Subject: Conditional Work Plan Approval, Fuel Leak Case No. RO0003225 and GeoTracker Global ID T10000009578, 2449 – 2451 Santa Clara Street, 2449 – 2451 Santa Clara Street, Alameda, CA 94501

Alameda County Department of Environmental Health (ACDEH) staff has reviewed the case file including the *Work Plan for Additional Phase II Subsurface Investigations*, dated September 4, 2018, and slightly revised on October 19, 2018. The work plan was prepared and submitted on your behalf by ERAS Environmental, Inc. Thank you for submitting the work plan.

TECHNICAL COMMENTS

SITE PLAN w/SOIL BORINGS LOCATIONS

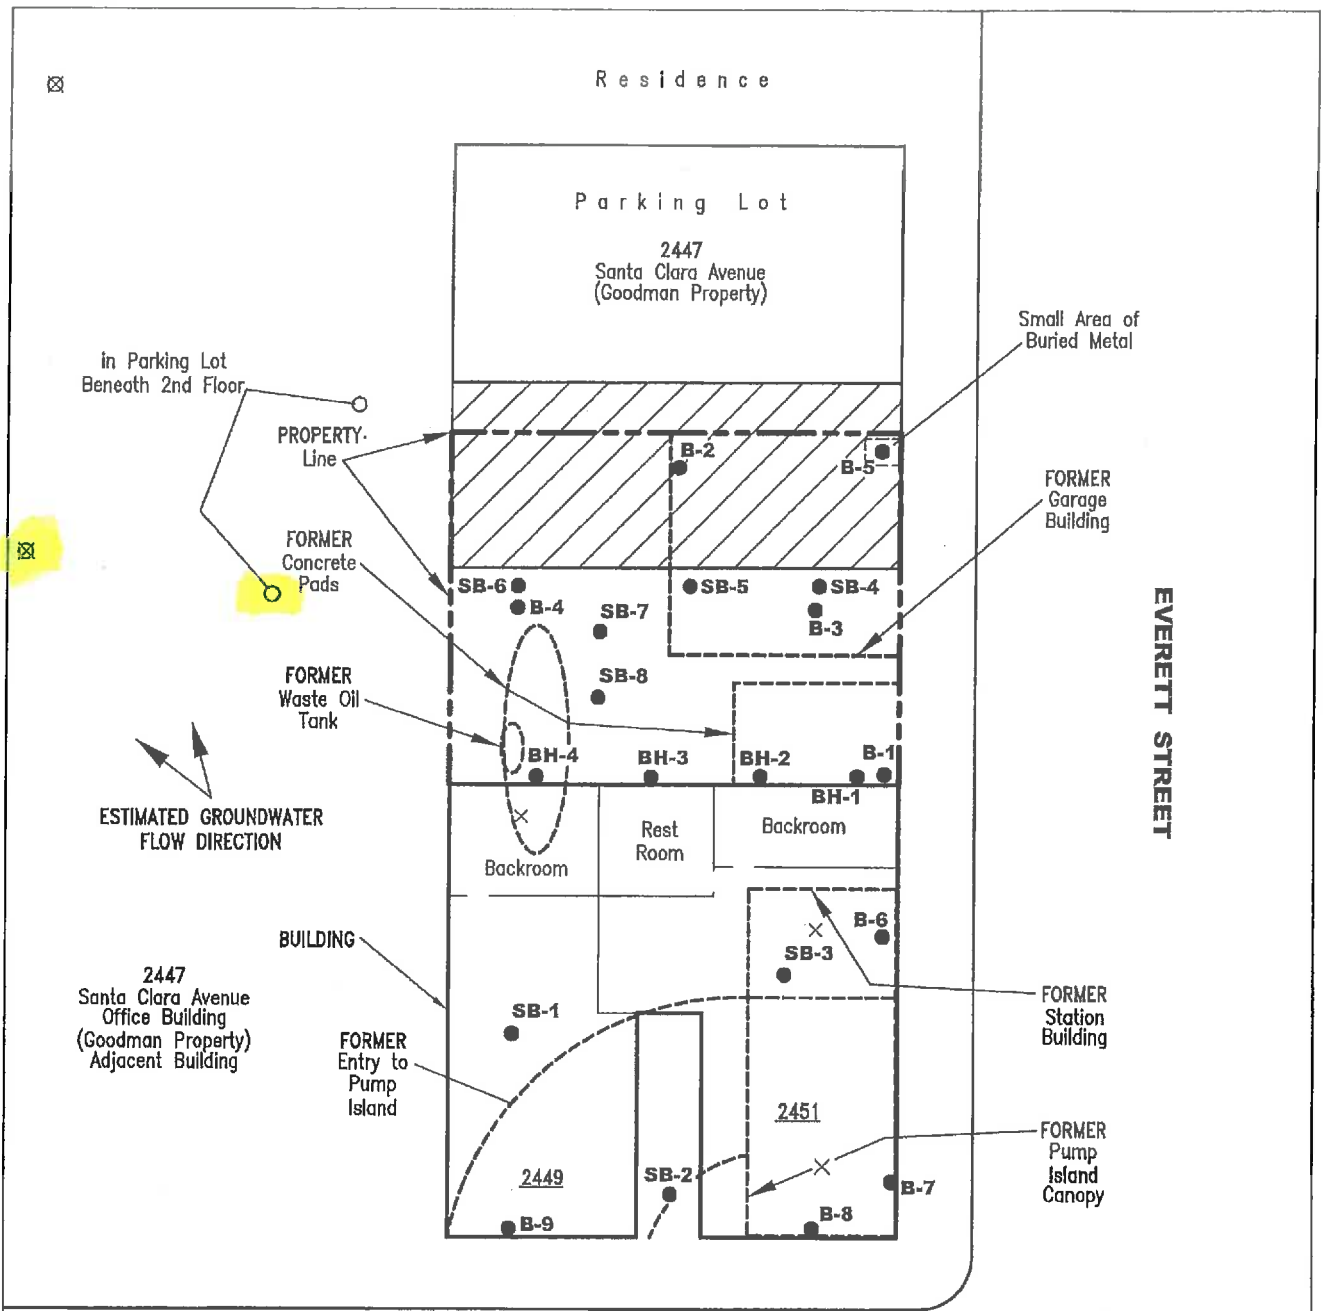
- a. **Additional Contingency Soil Bore** – A minimum of one additional contingency soil bore for soil and grab groundwater sample collection to the northwest of soil bore SB-6, which contains the highest residual soil contamination documented at the site. Additional step-out contingency soil bores maybe required to full define the lateral extent of contamination documented, as depicted in Attachment B.
